VILLAGES OF DEER RIVER SUBDIVISION

APPLICATION NUMBER 1 DATE November 20, 2014

REQUEST Subdivision

DETAIL SITE PLAN

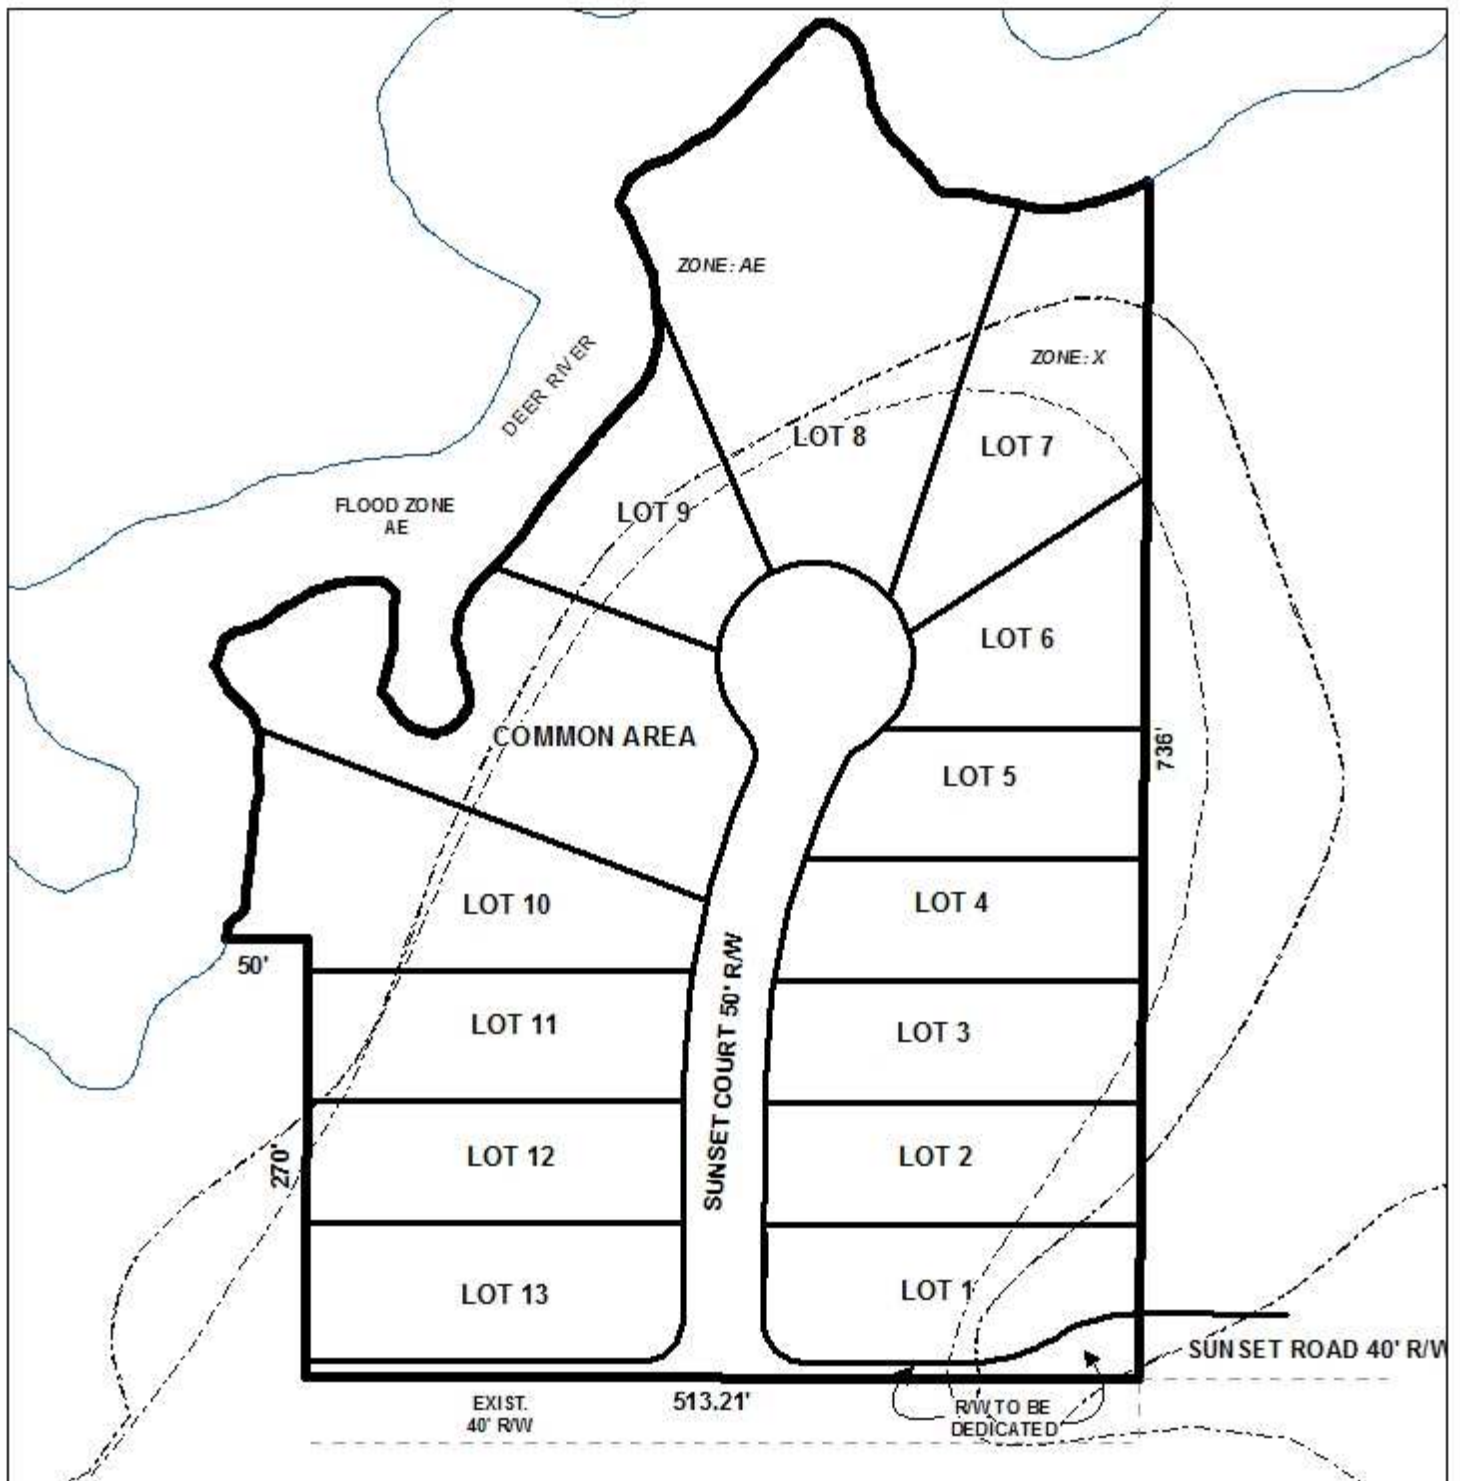
The lot sizes are labeled in both square feet and acres, and the proposed lots would exceed the minimum 15,000 square foot size requirements of Section V.D.2. of the Subdivision Regulations. It should be noted that the square footage provided for proposed Lots 3 and 6 does not appear to be accurate. The correct lot sizes should be placed in square feet and acres on the Final Plat, if approved.

The 25' minimum setback line is not illustrated as required by Section V.D.9. of the Subdivision Regulations. The setback should be illustrated along all frontages on the Final Plat, if approved.

The site fronts onto Sunset Road, an unpaved minor street, and is illustrated as having a 40' right-of-way. Mobile County Public Works records show that the road has a prescriptive right-of-way (right of way is the width of maintained right of way). The preliminary plat illustrates a 10' deep strip labeled as "right-of-way to be dedicated". Minor streets with no curb and gutter require a 60' right-of-way, and this dedication will provide 30' from the centerline of Sunset

Road as required. This dedication should be retained on the Final Plat, if approved. A note should be placed on the Final Plat stating that no future subdivisions will be allowed until Sunset Road is brought up to Mobile County standards.

It should be noted that Sunset Road appears to be approximately 16 feet in width. As such, the creation of a 13-lot subdivision, 1,100 feet west by a narrow unpaved road from Dauphin Island Parkway, should not be encouraged at this time. If Sunset Road were to be paved in asphalt and, at minimum, meet the road requirements of Section VIII.E.2.c. of the Subdivision Regulations, then the proposed access concerns would be substantially reduced.

The preliminary plat illustrates a proposed new road, referred to as "Sunset Court". Sunset Court is illustrated as having a 50' right-of-way, with a cul-de-sac proposed to have a turnaround diameter of 120'. A 50' right-of-way is appropriate if Sunset Court will have curb and gutter, otherwise, a 60' right-of-way should be provided.

As a mean of access management, a note should be placed on the Final Plat stating that each lot is limited to one curb cut to the proposed Sunset Court, and denied direct access to Sunset Road, with the size, design, and location of the curb cuts, to be approved by Mobile County Engineering and conform to AASHTO standards.

There is a common area shown on the preliminary plat. If approved, a note should be placed on the Final Plat stating that the maintenance of all common areas and detention facilities is the responsibility of the property owners and not Mobile County.

A portion of the site appears to contain floodplains and wetlands associated with a branch of Deer River. The potential presence of wetlands and floodplains indicate that the area may be environmentally sensitive; therefore, the approval of all applicable federal, state and local agencies for wetland and floodplain issues will be required prior to the issuance of any permits or land disturbance activities. A note should be placed on the Final Plat stating this requirement.
